REGULATORY INFORMATION DISTRIBUTION SYSTEM (RIDS)

SUBJECT: Application for amends to Licenses NPF-41, NPF-51 & NPF-74,  
 revising TS to allow implementation of guidance provided in  
 Generic Ltr 89-01, "Implementation of Programmatic Controls  
 for Radiological Effluent TS in Administrative Controls...."

**Subject: Palo Verde Nuclear Generating Station (PVNGS)**  
**Units 1, 2, and 3**  
**Docket Nos. STN 50-528/529/530**  
**Technical Specification Amendment Request**  
**Implementation of Generic Letter 89-01**  
**File: 92-F-005-419.05; 92-056-026**

Figure 5.1-1  
Site and Exclusion Boundaries

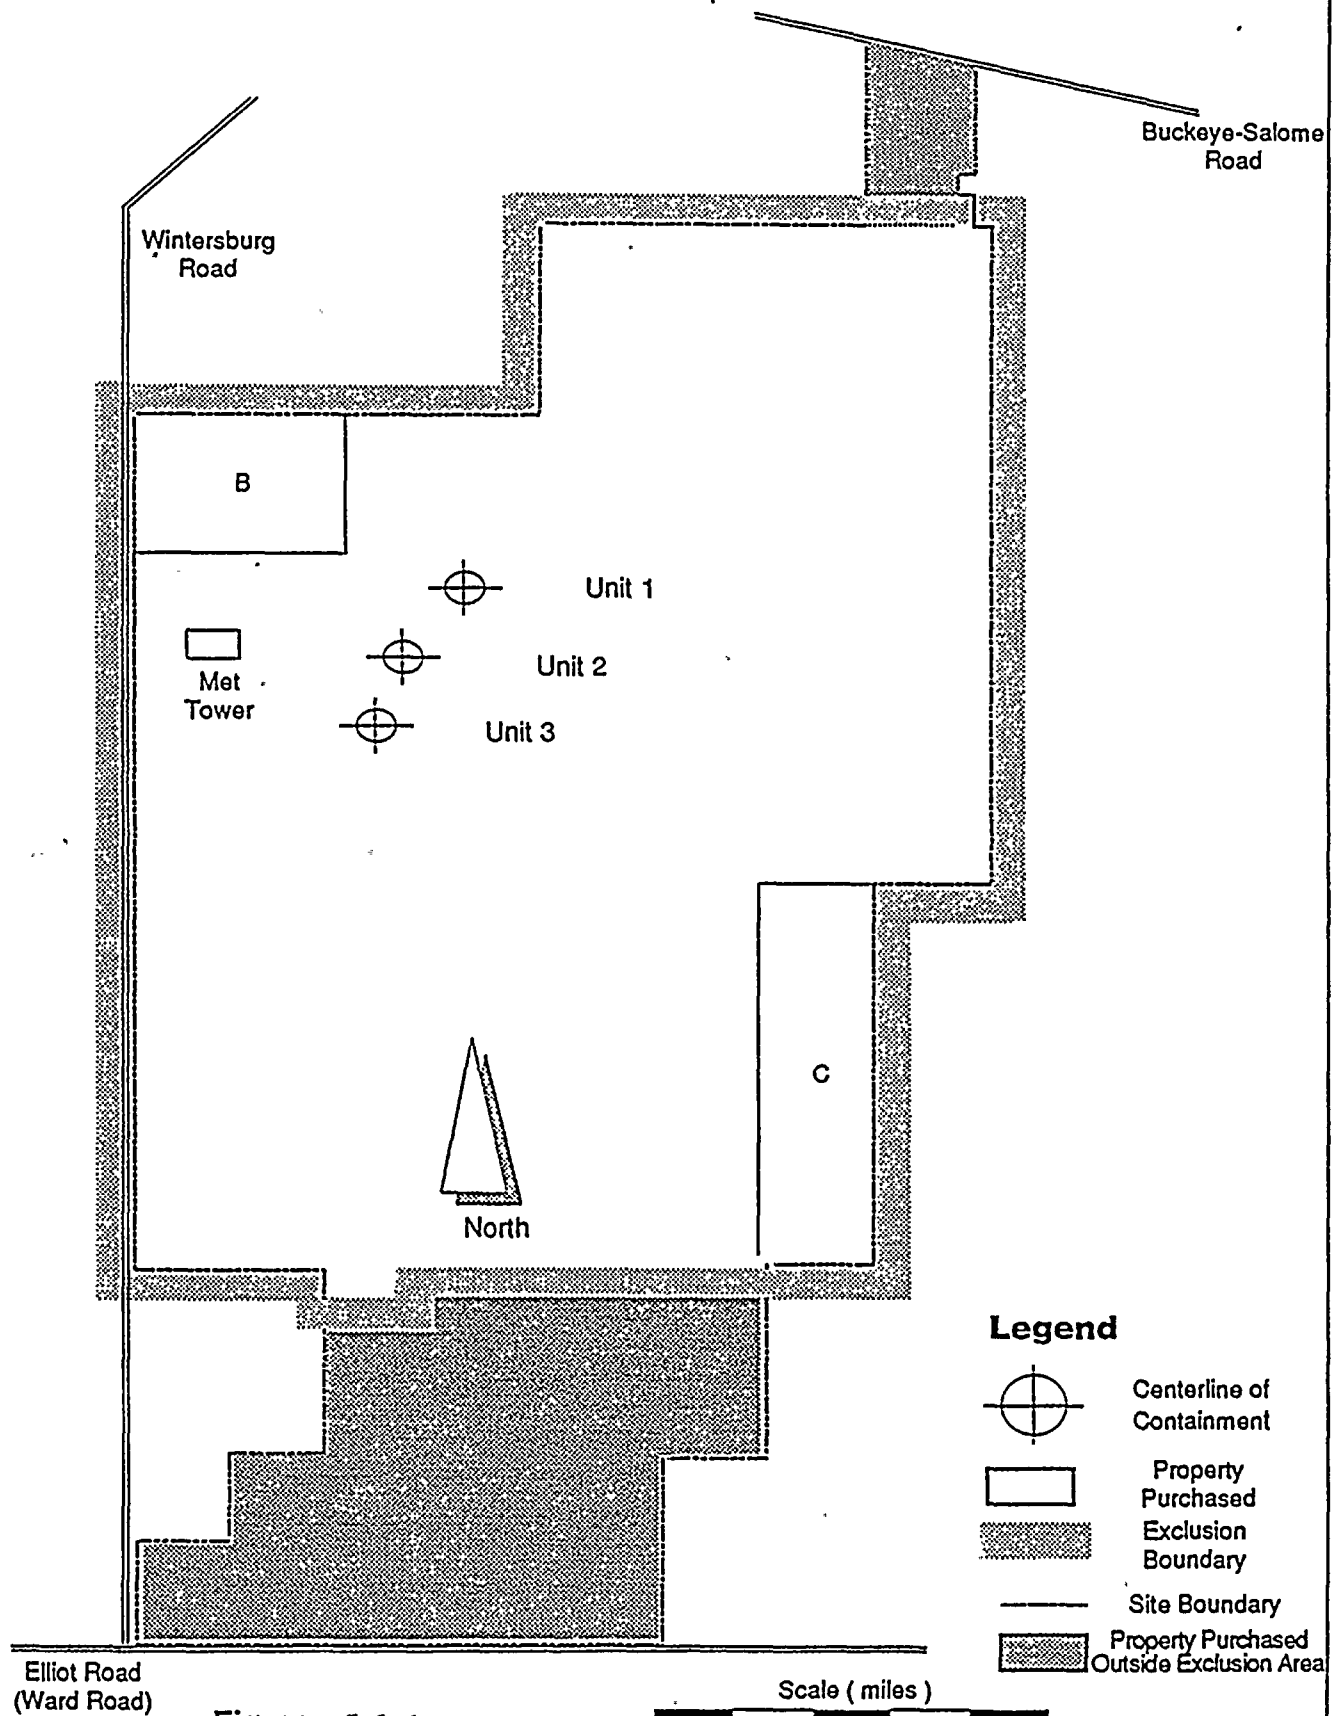
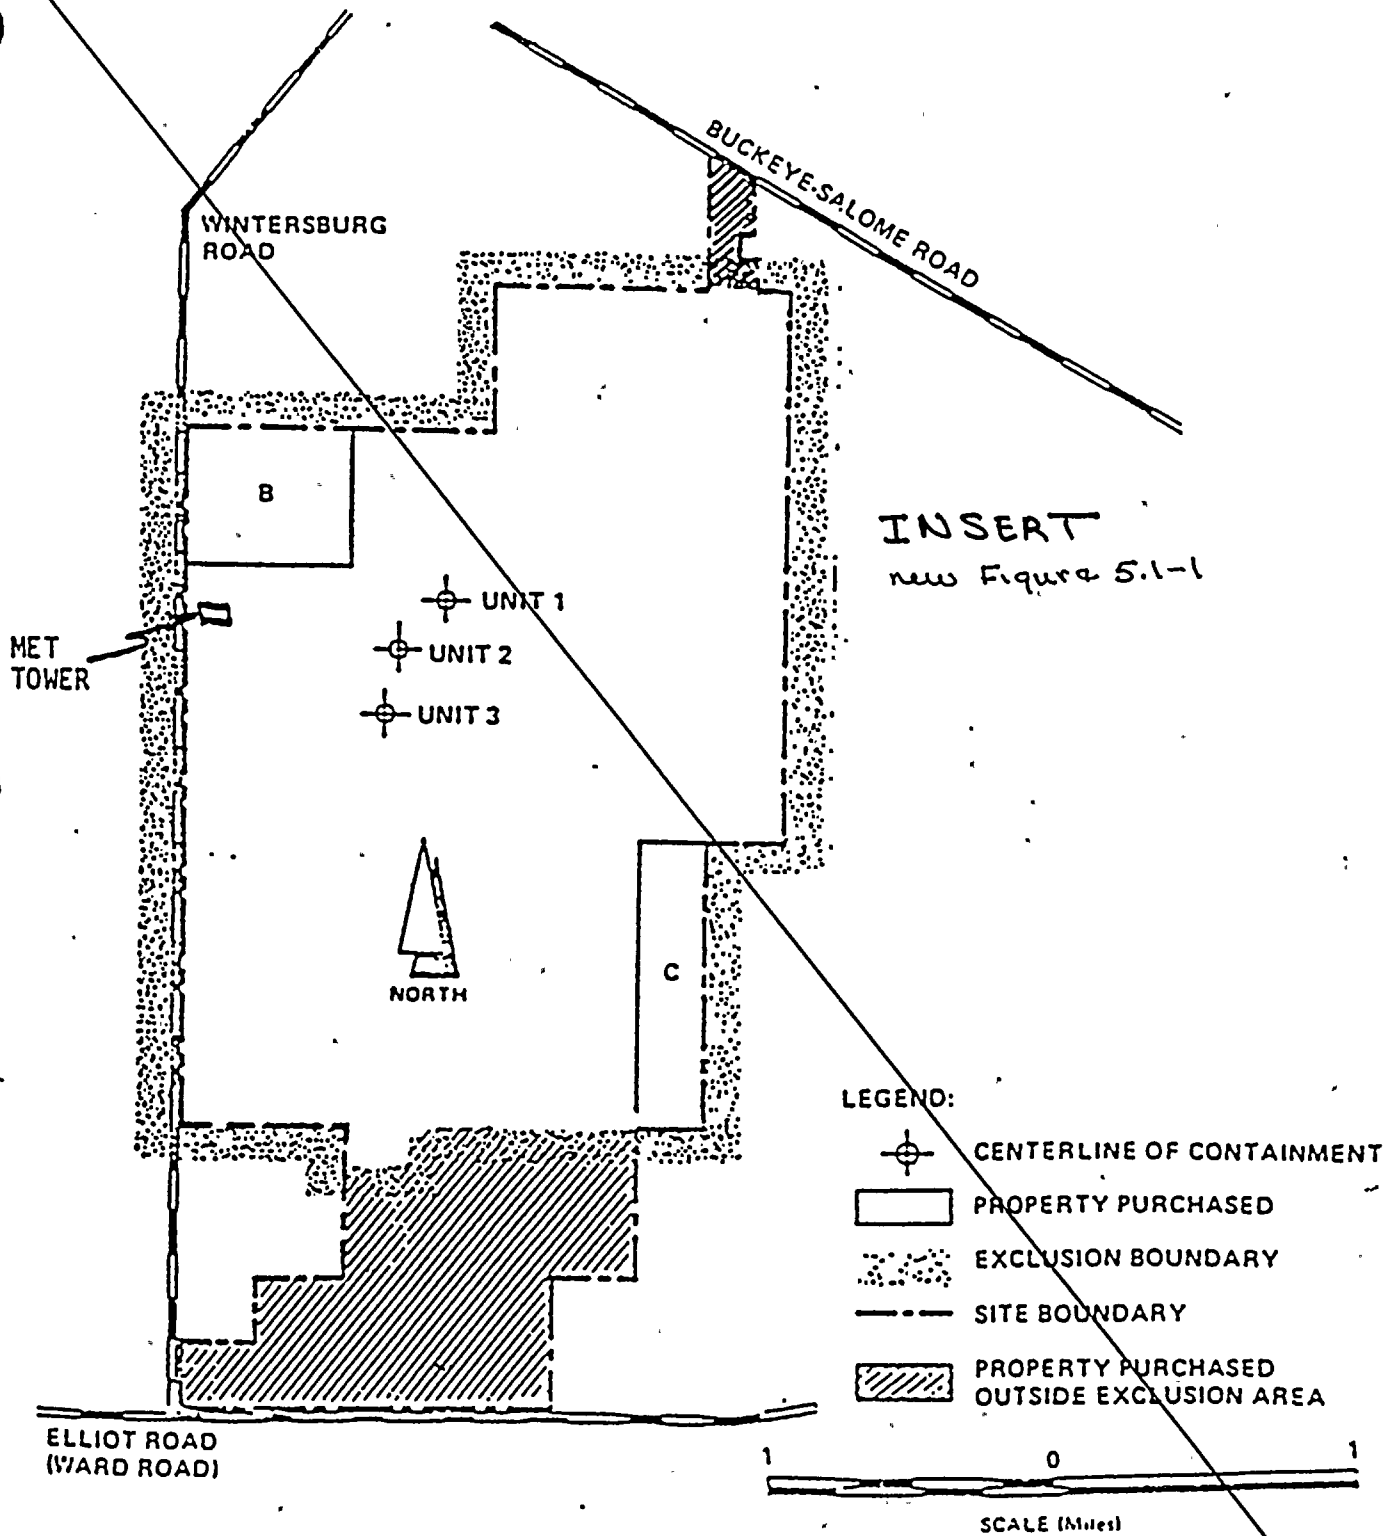
A second difference is that Figures 5.1-1, 5.1-2, and 5.1-3 have been enhanced. The revised figures provide information that is more clear than the existing figures. Figure 5.1-3 has additional changes: the fuel building exhaust is 100'-3" from center line of containment, not 112'-9"; and the elevation of the exhaust point above grade for the Condenser Vacuum is 109'-9" not 116'. These changes are administrative, i.e., the exhaust locations have not changed, and the original distances indicated were incorrect since issuance of the unit licenses.

INSERT  
new Figure 5.1-1
